**CITY OF SAINT PETER, MINNESOTA  
AGENDA AND NOTICE OF MEETING**

**RE:** Standard Detail Updates for 2014

The City has standard details that are used for construction of public infrastructure through out the City. Recently the American Disabilities Act (ADA) required changes in public standards; it is the City's intention to stay in compliance with ADA requirements and the changes are reflected in the following City standards.

STANDARD DETAIL  
PLATE NO:  
**7020A**

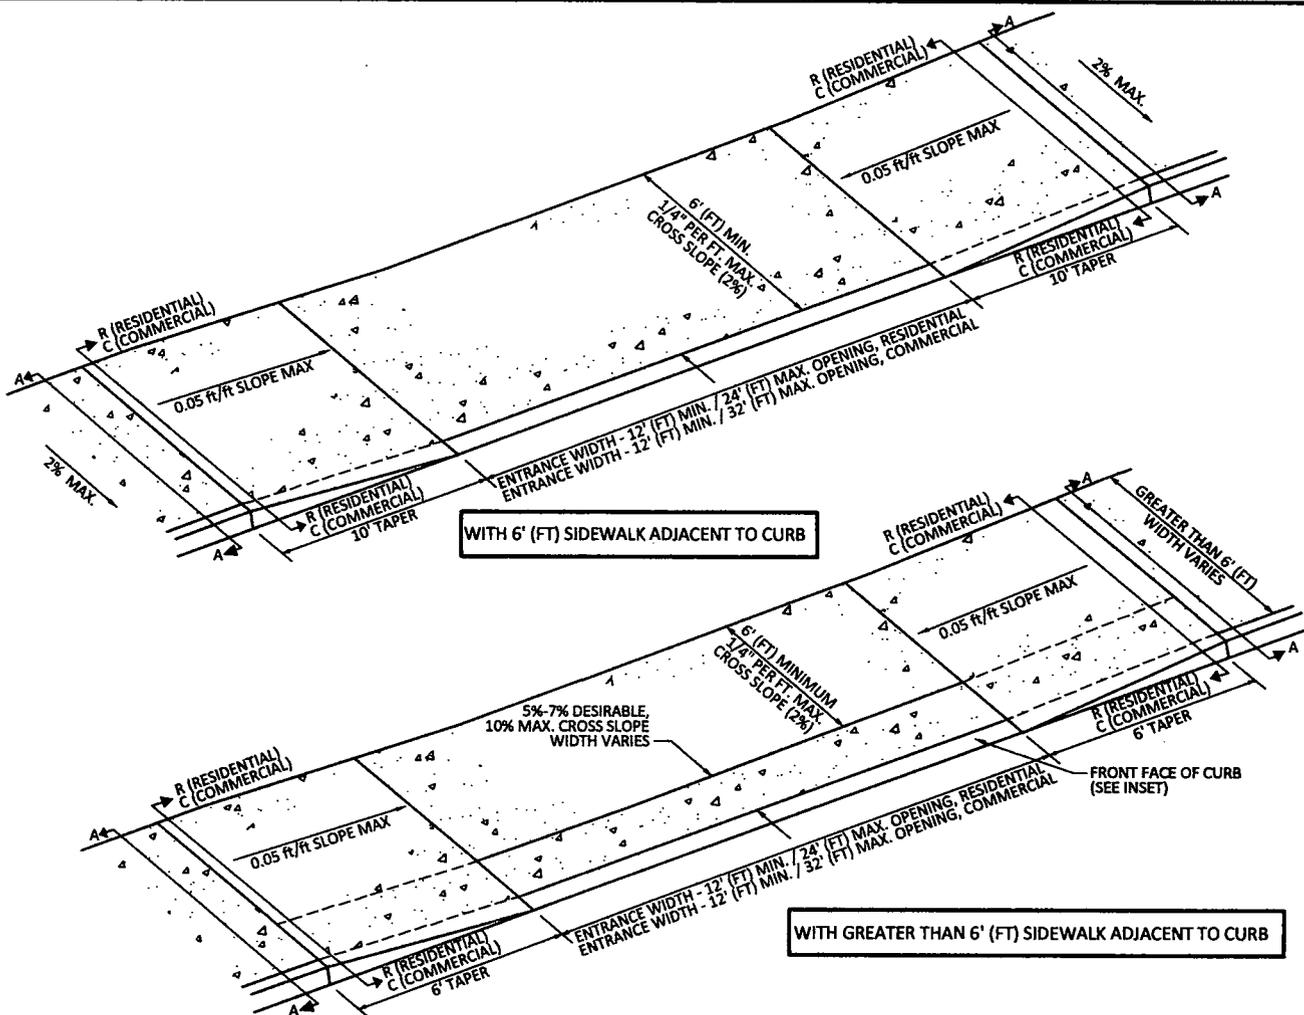
7020A – Residential/Commercial Concrete Walk and apron adjacent to curb

Added: or recycled concrete or bituminous

STANDARD DETAIL  
PLATE NO:  
**7020C**

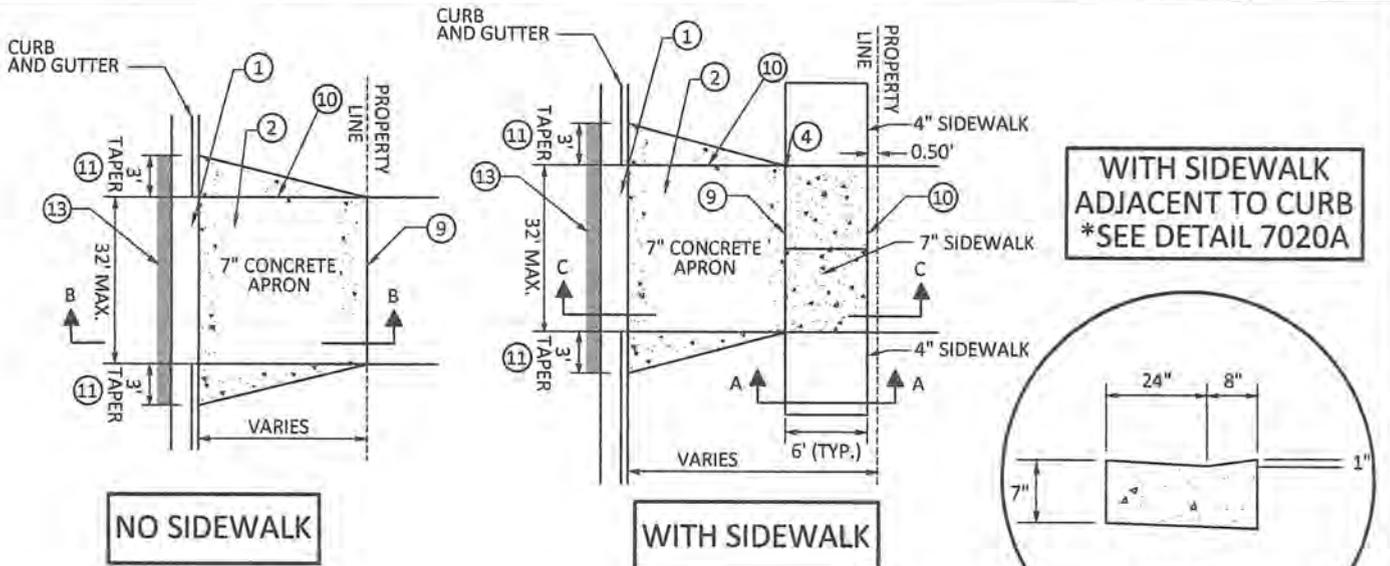
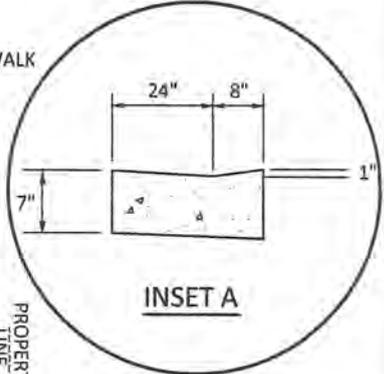
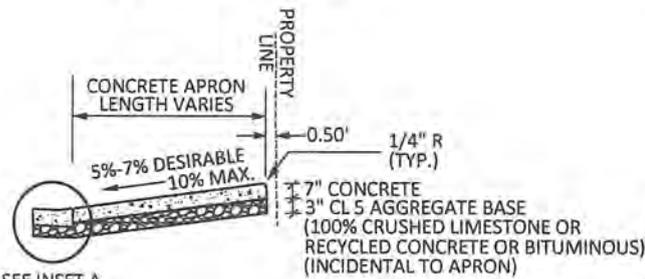
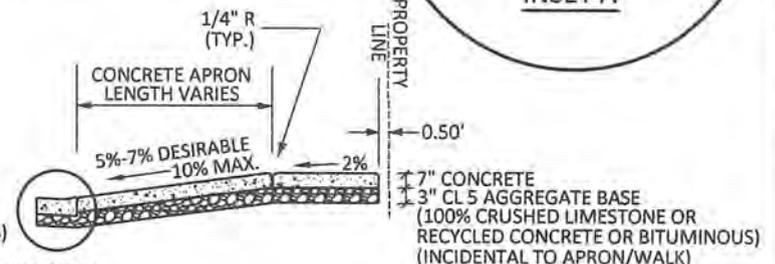
7020 C – Commercial Concrete Walk and Apron

Added: or recycled concrete or bituminous

STANDARD DETAIL  
PLATE NO:  
**7020R**

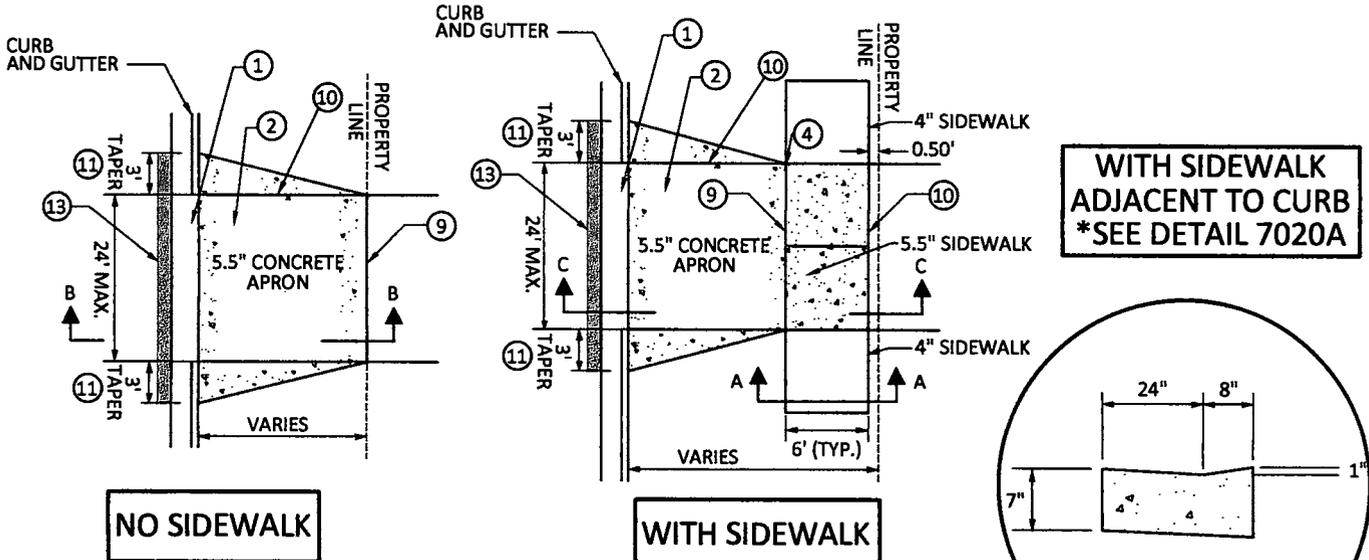
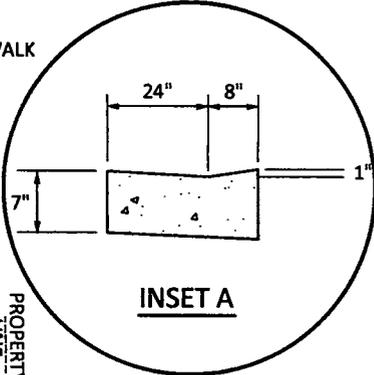
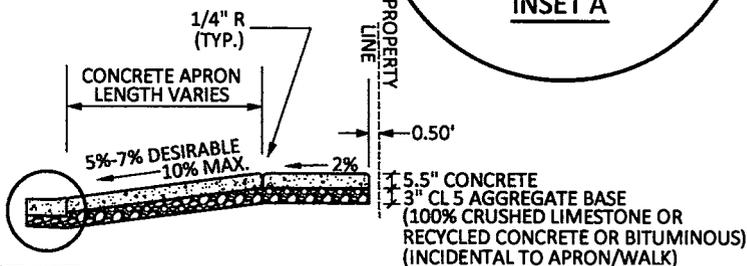
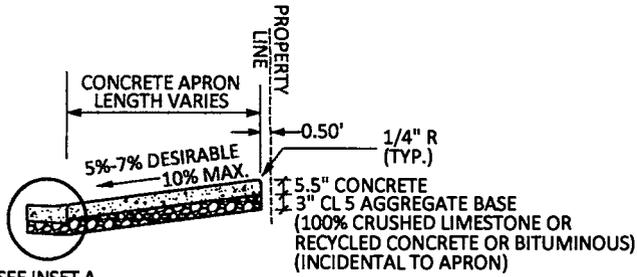
7020R – Residential Concrete Walk and Apron

Added: or recycled concrete or bituminous
